UNITED STATES PATENT AND TRADEMARK OFFICE

APPLICATION NO.	FILING DATE	FIRST NAMED INVENTOR	ATTORNEY DOCKET NO.	CONFIRMATION NO.
10/612,475	07/02/2003	Charles Peter deCler	1945.185US01	3132
23552	7590	05/18/2006	EXAMINER	
MERCHANT & GOULD PC P.O. BOX 2903 MINNEAPOLIS, MN 55402-0903			DUNWOODY, AARON M	
			ART UNIT	PAPER NUMBER
			3679

Office Action Summary

DETAILED ACTION

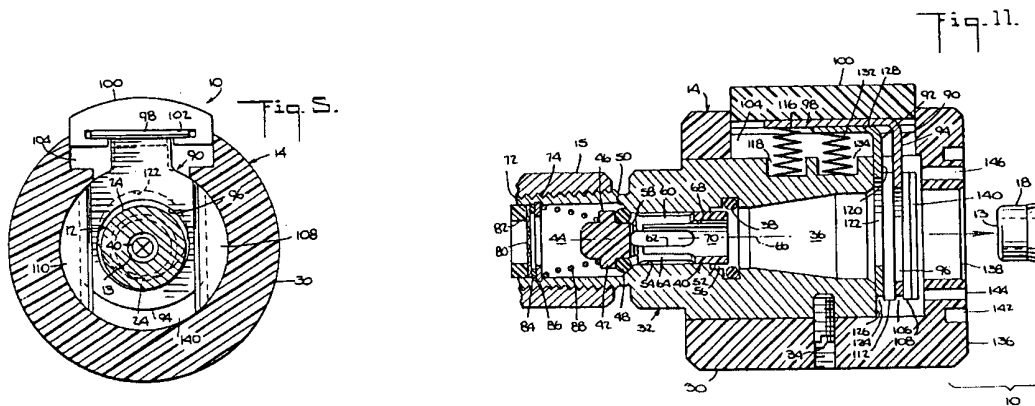
Applicant argues that a top portion of coupling member 14 disclosed by Carstens does not protrude from the coupling body 32 at least a same distance as an outermost portion of button 100. The Examiner disagrees.

As illustrated in Figures 5 and 11 above, the outer member 100 can be full contained within the space/slot 104 such that a top portion of the wall protrudes from the outer surface at least a same distance as an outermost portion of the outer member protrudes from the outer surface. Therefore, Carstens meets the claim limitation.
